Stage 1 Road Safety Audit – Designers Response
Former Tollgate Hotel, Gravesend, Kent

Project Details and Authorisation	
Project:	Former Tollgate Hotel, Gravesend, Kent
Report Title:	A2 westbound slips / A227 Roundabout Stage 1 RSA
Date:	27/08/2025
Document reference and revision:	22052-MA-RP-RSA01 Rev A
Produced by:	Markides Associates Ltd
On behalf of:	National Highways
Prepared by	
Name:	Jennifer Baker
Position:	Director
Signed:	<i>J Baker</i>
Organisation:	Markides Associates Ltd
Date:	29/08/2025
Approved by	
Name:	Nigel De Wit
Position:	Spatial Planner
Signed:	<i>NDW</i>
Organisation:	National Highways
Date:	29/08/25

Introduction	
Scheme Details:	The proposed scheme comprises of an interim capacity improvement scheme for the westbound off slip of the A2 'Gravesend, Wrotham and Services' dumbbell roundabout junction. Currently, the flare on the approach to the roundabout is marked as being for left turning vehicles only. The interim scheme proposes to amend this road marking to allow the flare to be utilised for all movements, as the right turn movement is the dominant flow. Lining changes are also proposed to the roundabout gyratory to clearly delineate two circulation lanes

Drawing Title
ROUNABOUT SIGN AND
ROAD MARKINGS PROPOSAL

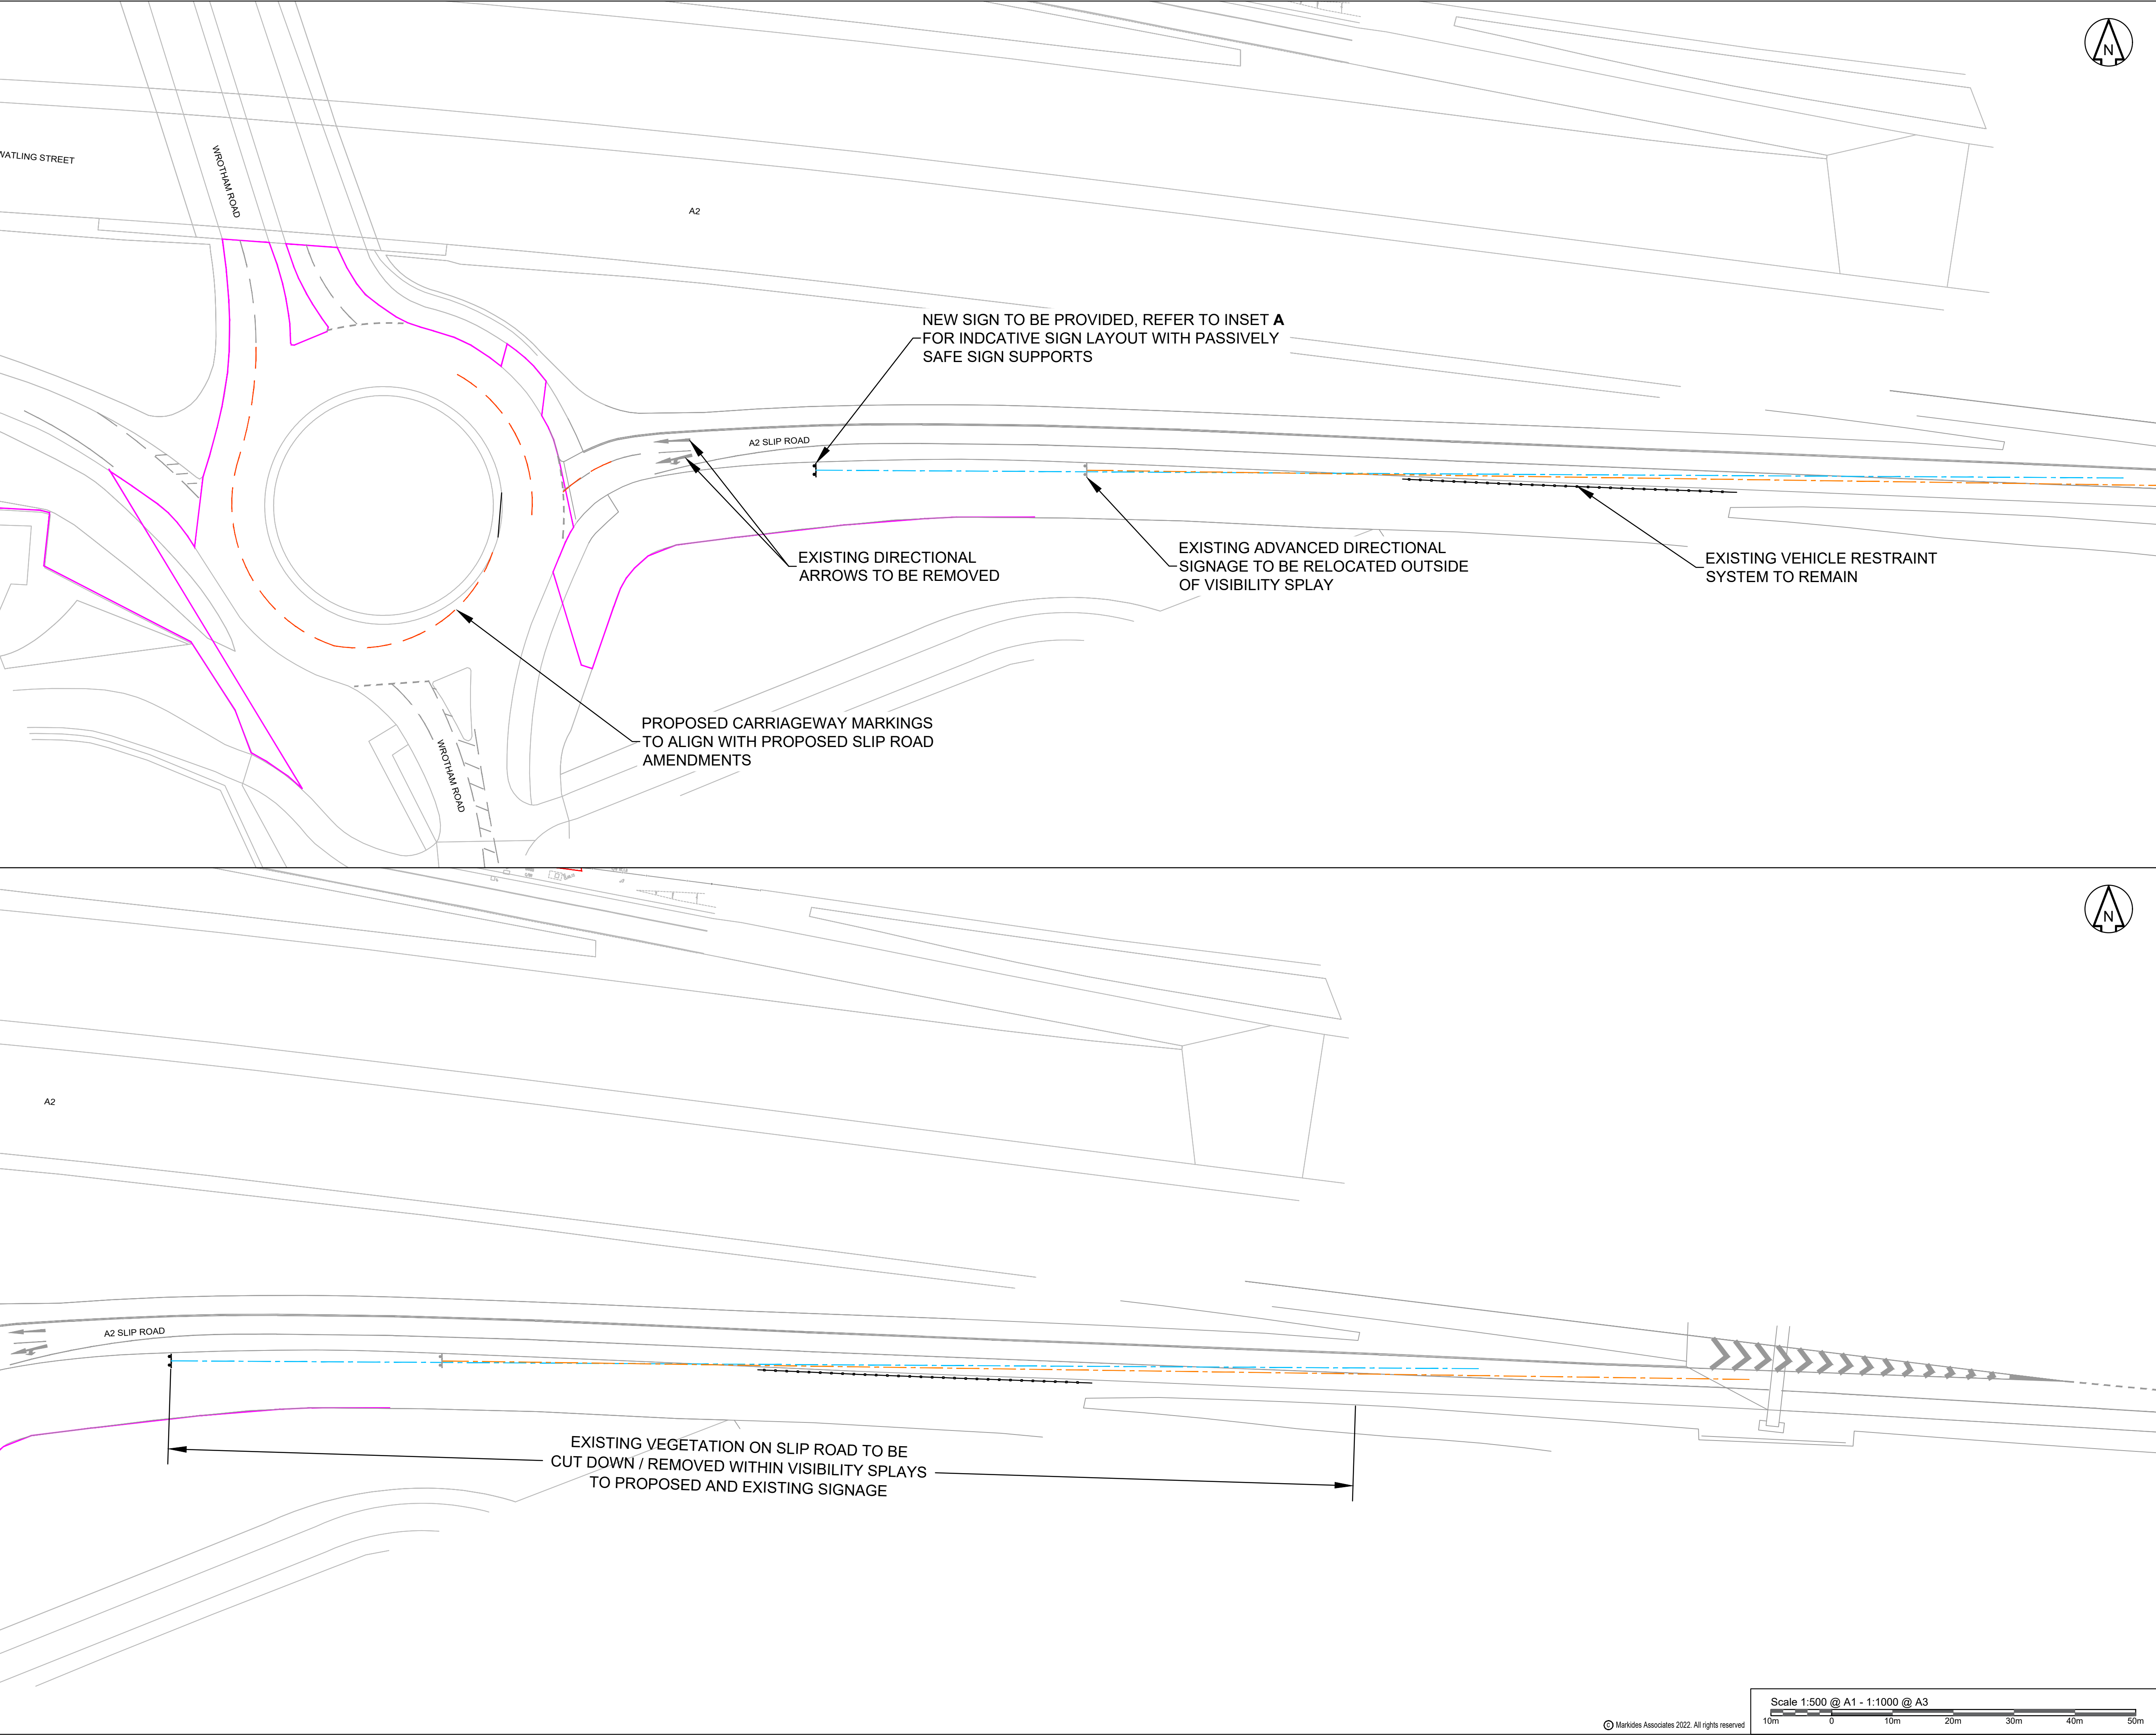
Road Safety Audit Decision Log					
Problem	RSA Problem	RSA Recommendation	Design Organisation Response	Overseeing Organisation Response	Agreed RSA Action
A-01	Observations at the roundabout noted that drivers turning right from the southbound approach towards the A2 westbound on-slip had a tendency to follow the kerb line of the central roundabout island. The proposals seek to encourage drivers turning right from the A2 westbound off-slip to form two lanes. This arrangement may increase the risk of a collision on the circulatory carriageway at the exit for the A2 westbound on-slip. In this scenario, a slower moving vehicle turning towards the A2 westbound on-slip could be overtaken by a faster moving vehicle turning right from the A2 westbound off-slip. A lack of lane use clarity in the carriageway markings may increase the risk of collisions on the circulatory carriageway.	It is recommended that a spiral arrangement is provided for vehicles turning right onto the A2 westbound on-slip to direct drivers from the offside (lane 2) on entry to the roundabout to the nearside (lane 1) as they exit onto the A2 westbound on-slip.	Agreed Please see Drawing Number 22052-MA-XX-DR-C-0102 P07, which has been revised to show a spiral arrangement as requested.	The Design Organisation's response to amend the road markings is acceptable. These should be subject to RSA at detailed design.	The Design Organisation's response is agreed subject to RSA at the detailed design stage.

Road Safety Audit Decision Log					
Problem	RSA Problem	RSA Recommendation	Design Organisation Response	Overseeing Organisation Response	Agreed RSA Action
A-02	A lane use direction sign is proposed on the slip road verge. This indicates two lanes and is located about 120m in advance of the development of two lanes on the carriageway. Drivers approaching this sign may observe this sign potentially over 200m from the development of two lanes and mistake the hard shoulder for a live lane. This could be a problem, especially for tired drivers or drivers unfamiliar with UK carriageway markings, i.e. those travelling from mainland Europe. The location of the lane use sign may increase the risk of a collision with a stationary or broken-down vehicle on the hard shoulder.	It is recommended that the lane use sign is located closer to the point where the slip road widens into two lanes without compromising visibility to the give way line.	Agreed Please see Drawing Number 22052-MA-XX-DR-C-0102 P07, which has been revised to show the sign located on the immediate approach to the widening to two lanes. We have also identified that the existing ADS will need to be moved further from the edge of the carriageway to ensure the sign is visible.	The Design Organisation's response to amend the road signs is acceptable. These should be subject to RSA at detailed design.	The Design Organisation's response is agreed subject to RSA at the detailed design stage.

A-03	A lane use direction sign is proposed on the slip road verge. This indicates two lanes for Gravesend, the A227(N) and the services. However, drivers seeking the services would be required to change lanes under the bridge or on the northern roundabout to make a right turn into the services. This may increase the risk of collisions involving lane changes under the bridge or on the northern roundabout.	It is recommended that the word "Services" is used for the right lane only and that the text is relocated above the right lane arrow on the sign	Agreed Please see Drawing Number 22052-MA-XX-DR-C-0102 P07, which has been revised to show the altered sign face.	The Design Organisation's response to amend the road sign is acceptable. These should be subject to RSA at detailed design.	The Design Organisation's response is agreed subject to RSA at the detailed design stage.

Road Safety Audit Decision Log					
Problem	RSA Problem	RSA Recommendation	Design Organisation Response	Overseeing Organisation Response	Agreed RSA Action
A-04	Should the recommendation in Problem A-02 be taken up, the proposed sign location is likely to be placed where no road restraint system is provided. Should the recommendation in Problem A-02 be rejected, then the proposed sign location would be behind a road restraint system that is provided specifically for the existing roadside cabinet and not a sign support structure. Insufficient provision for secondary collisions involving errant vehicles may increase the injury severity for the errant vehicle occupants and/or other road users in the path of an errant vehicle.	It is recommended that a passively safe sign support structure is provided.	Agreed Please see Drawing Number 22052-MA-XX-DR-C-0102 P07, which has a note introduced to require passive safe sign supports are used.	The Design Organisation's response to provide a passively safe post is acceptable. This should be subject to RSA at detailed design.	The Design Organisation's response is agreed subject to RSA at the detailed design stage.

Road Safety Audit Decision Log					
Problem	RSA Problem	RSA Recommendation	Design Organisation Response	Overseeing Organisation Response	Agreed RSA Action
A-05	Whilst the provision of carriageway arrows or text is often useful for drivers, there is the risk here that the proposed inclusion of the ahead arrows may be confusing for drivers. This is especially a problem when used on a circulatory carriageway such as proposed, where the ahead arrows could direct drivers from both lanes into the single lane A2 westbound on-slip. An alternative arrangement of worded destinations is likely to be easily confused with such as A227(S) and A227(N) also unlikely to fit in the available carriageway width and potentially increasing the risk of a loss of control type collision for a powered two wheeler on the worded markings that would be placed at a point where these users may be banked over whilst negotiating the entry curve to the roundabout.	It is recommended that the carriageway arrow markings or any alternative worded markings are omitted from the proposals	Agreed Please see Drawing Number 22052-MA-XX-DR-C-0102 P07, which has omitted the carriageway arrows.	The Design Organisation's response to remove the arrow markings is acceptable at this stage but a review of all road markings should be carried out at the detailed design stage and then be subject to RSA to ensure a clear and consistent approach is used.	The Design Organisation's response is agreed subject to detailed design and RSA at that stage.
